Model: NAD 30S/30/40 Bridge Unit		Date: 15-Nov-99	No.: MA688001
Modified Article: Base: Bridge Unit		Prepared by: E. Fukuyama	
From: Technical Service Dept., GTS Division			
Reason for Modification:	<input type="checkbox"/> Parts catalog correction <input type="checkbox"/> To facilitate assembly <input type="checkbox"/> Part standardization	<input type="checkbox"/> Vendor change <input type="checkbox"/> To improve reliability <input checked="" type="checkbox"/> Other	<input type="checkbox"/> To meet standards (      )

Model: NAD 30S/30/40 Bridge Unit		Date: 30-Nov-99	No.: MA688002
Modified Article: Spring Plate and Grounding Wire		Prepared by: M. Kitajima	
From: Technical Services Dept., GTS Division			
Reason for Modification:	<input type="checkbox"/> Parts catalog correction <input type="checkbox"/> To facilitate assembly <input type="checkbox"/> Part standardization	<input type="checkbox"/> Vendor change <input checked="" type="checkbox"/> To improve reliability <input type="checkbox"/> Other	<input type="checkbox"/> To meet standards (      )

Model: NAD 30S/30/40 Bridge Unit		Date: 28-Dec-00	No.: MA688003
Modified Article: Gear - 21Z		Prepared by: E. Fukuyama	
From: Technical

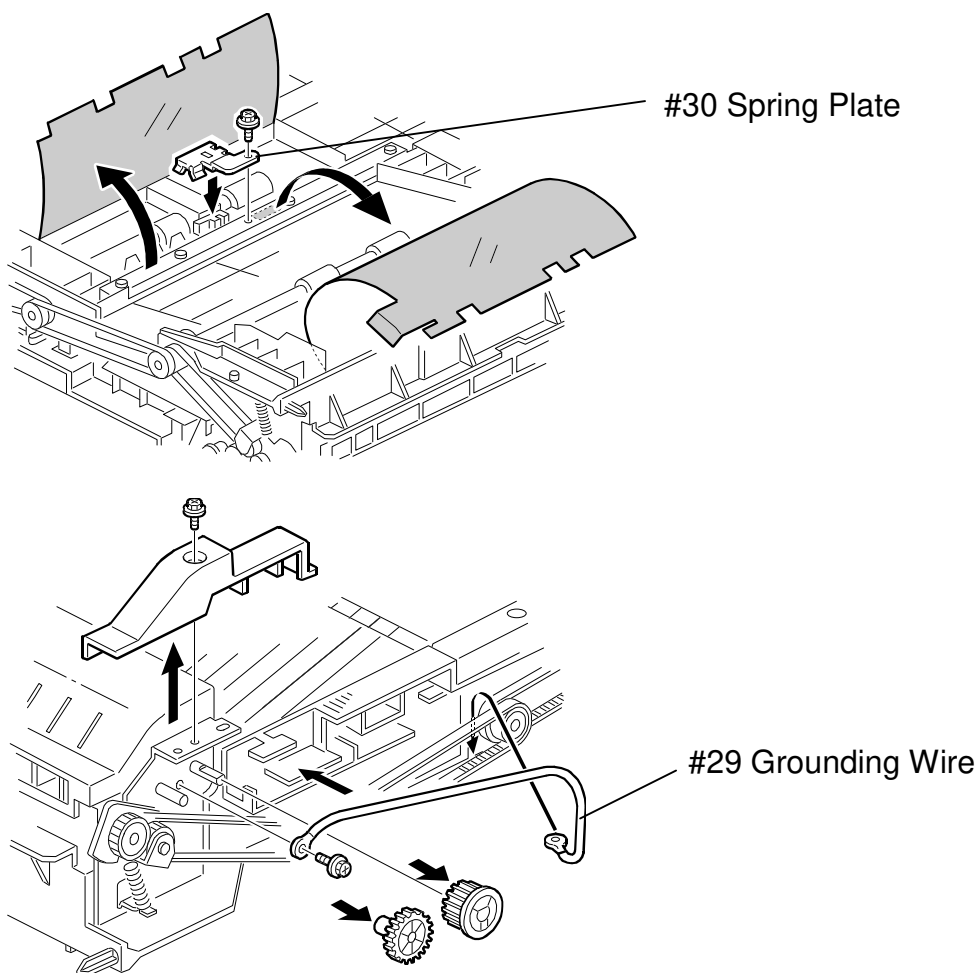
Old part number	New part number	Description	Q'ty	Int	Page	Index	Note
	A2845510	Grounding Wire	0-1	-	5	*29	* New Index
	A6883914	Spring Plate	0-1	-	5	*30	* New Index

To reduce the occurrences of paper jams caused by static electricity buildup, the parts listed above have been added to the bridge unit as shown in the illustration below.

Unfortunately, the cut-in serial number for this modification is not available. We estimate that the modification was applied from March 1999 bridge unit production runs.

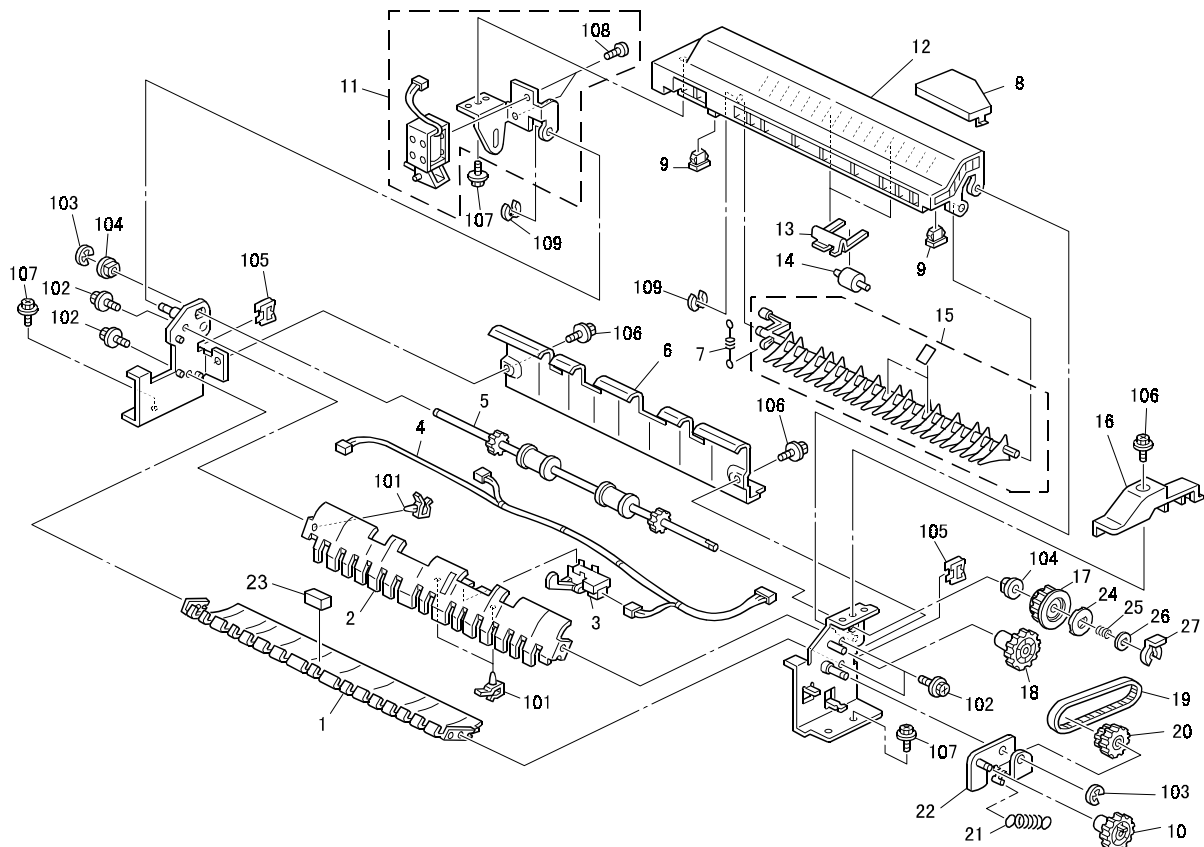
If an object gets caught between the exit rollers and exit cover, this can cause damage to both the object itself and the drive gear. To ensure that damage does not occur, a torque limiter has been added to the drive gear.

Old part number	New part number	Description	Q'ty	Int	Page	Index	Note
AB014056	AB014174	Gear – 21Z	1-1	X/X	3	17	*1
-	A6884473	Disk : Torque Limiter	0-1	-	3	24	*1
-	AA063332	Pressure Spring	0-1	-	3	25	*1
-	A6884474	Spacer : T=2	0-1	-	3	26	*1
-	08050097	Ring Separator	0-1	-	3	27	*1

\*1 As a set X/O from old part to new part.
